CHANGE NOTICE

Re.: CN2565S, CN2565S1

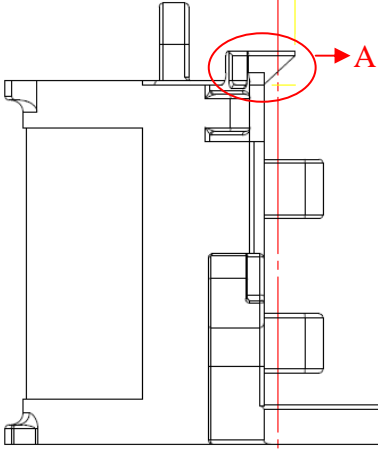
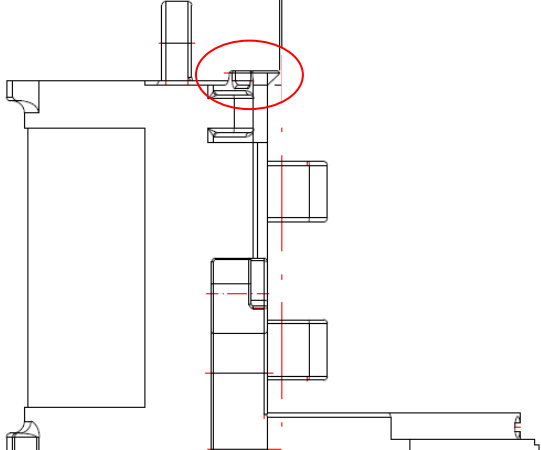
In order to provide larger space between Magazine and Contact trip guide and avoid hurting user's finger, we are going to change the design as below information.

Part	Magazine	
Part No.	#21371840015	#21371840115
Drawing	<p>Original</p> 	<p>New</p> 
Price	US\$3.75	
Design Change	Make A area smaller.	
Interchangeable	Part is interchangeable. Scrap inventory and provide new version from now on.
